Central™
Semiconductor Corp.
145 Adams Avenue, Hauppauge, NY 11788 USA
Tel: (631) 435-1110 • Fax: (631) 435-1824
www.centralsemi.com
mailto:processchange@centralsemi.com
http://www.centralsemi.com/processchange

PCN # 107

Process Change Notice

CP392V / CP792V Chip Geometry

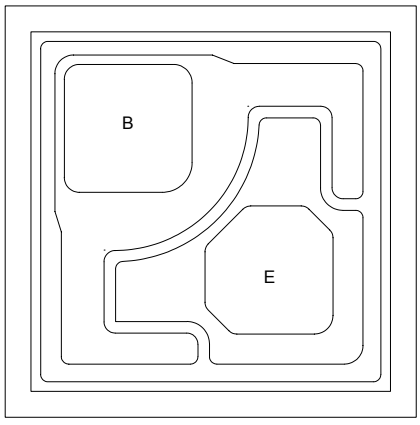
An overall reduction of the die area.

The CP192V chip process currently measures 13 x 17 mils and is being replaced by the CP392V chip process which measures 11 x 11 mils.

The CP592V chip process currently measures 12 x 20 mils and is being replaced by the CP792V chip process which measures 11 x 11 mils.

To accommodate assemblies of extremely small surface mount, epoxy molded packages.

This change does not affect the electrical characteristics of any device.

Die Size:	11 x 11 mils
Die Thickness:	7.1 mils
Bond Pad Area (Base):	3.7 x 3.7 mils
Bond Pad Area (Emitter):	3.7 x 3.7 mils
